Drainage Report

Dutch Bros Coffee (CO0907)

5810 Omaha Boulevard,
Colorado Springs,
Colorado 80915

PPR2413

Title:
PROPOSED DRAINAGE PLAN
5810 OMAHA BLVD
COLORADO SPRINGS, CO 80915

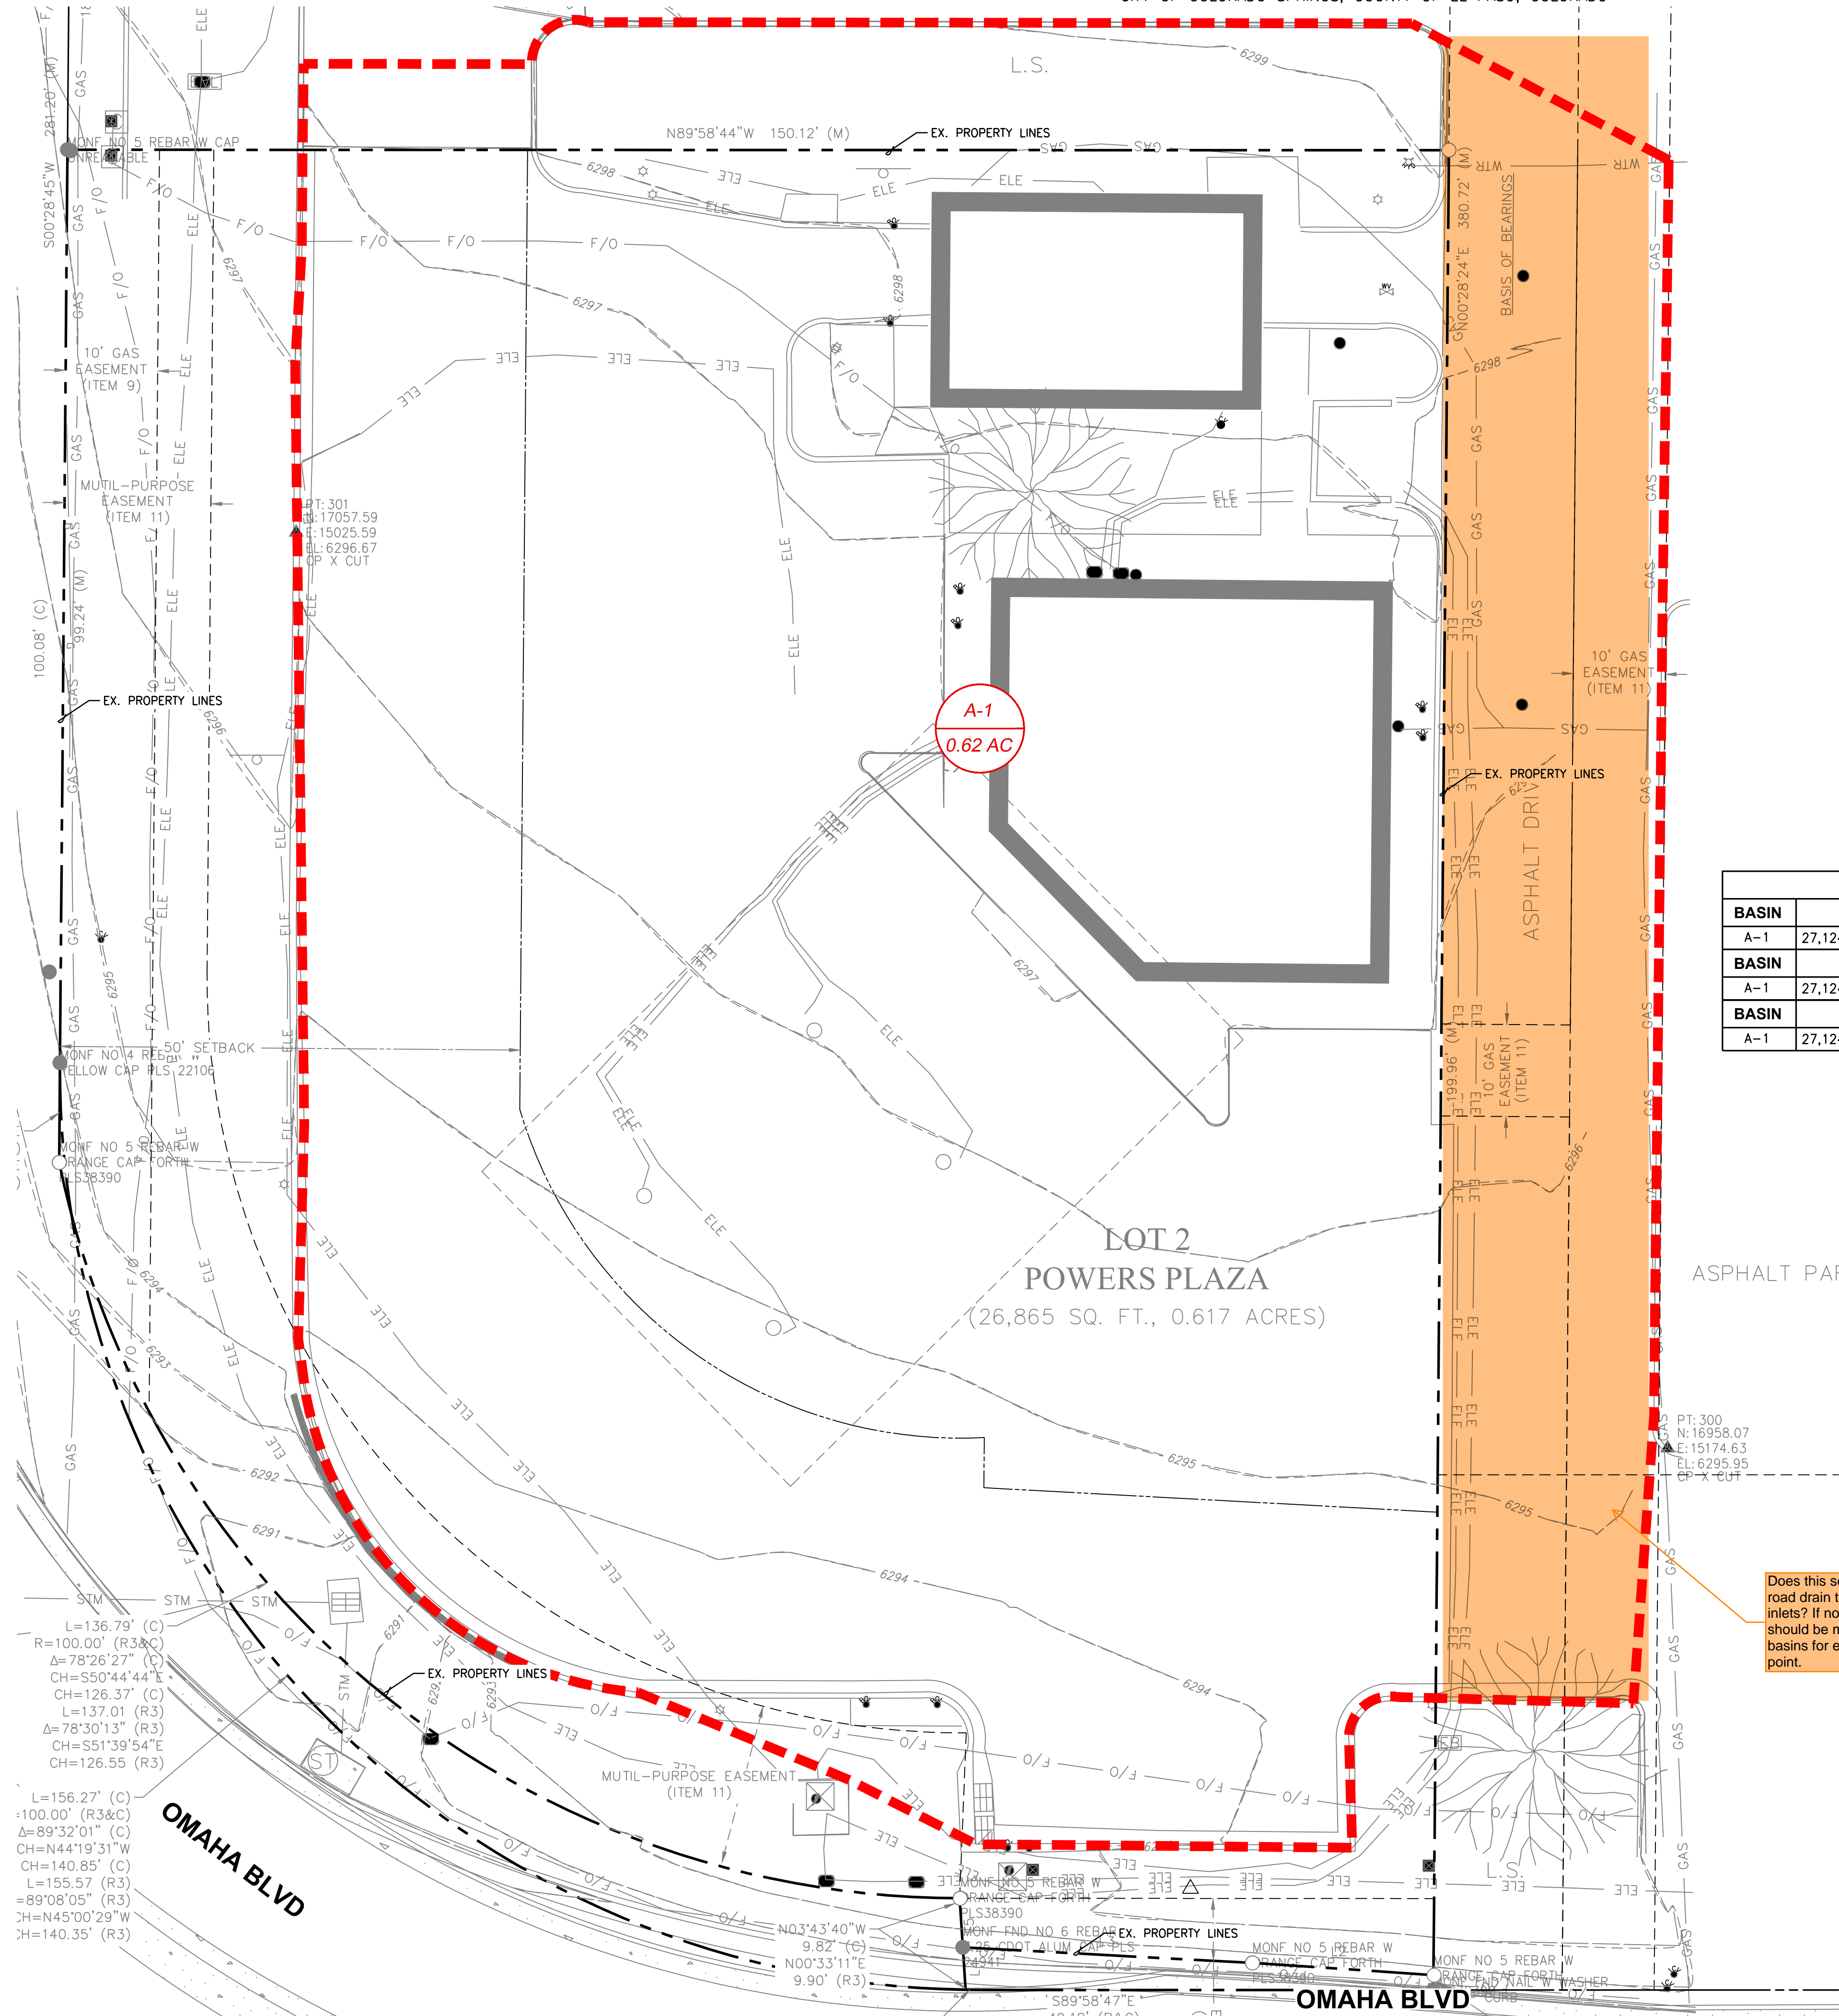
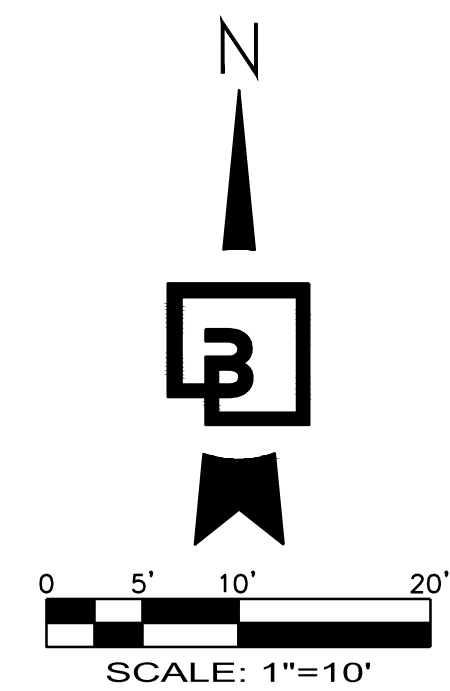
This column is the second Tc and 60 minutes is an unreasonable Tc for the site. What Tc was actually used?

Does this section of the road drain to those inlets? If not, there should be multiple basins for each design point.

Figure 6-5. Colorado Springs Rainfall Intensity Duration Frequency

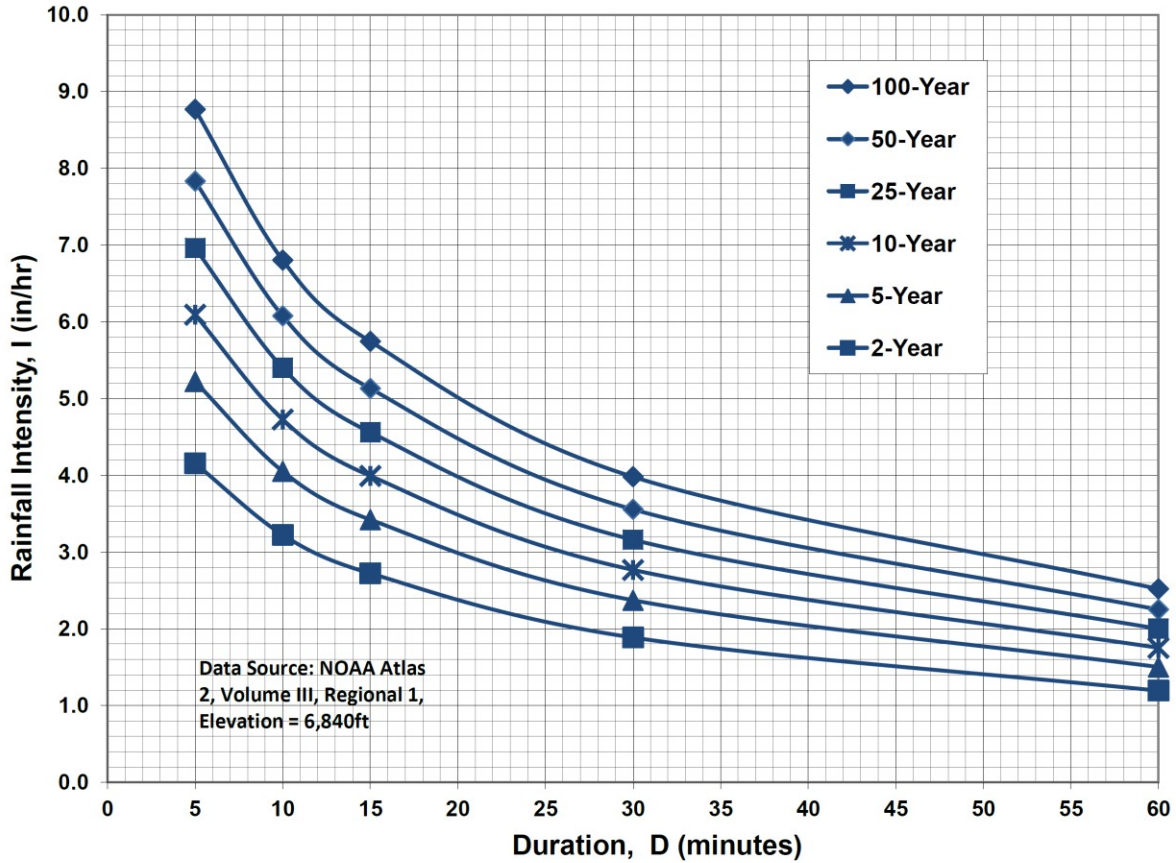
Please use DCM table 5-1 for runoff coefficients
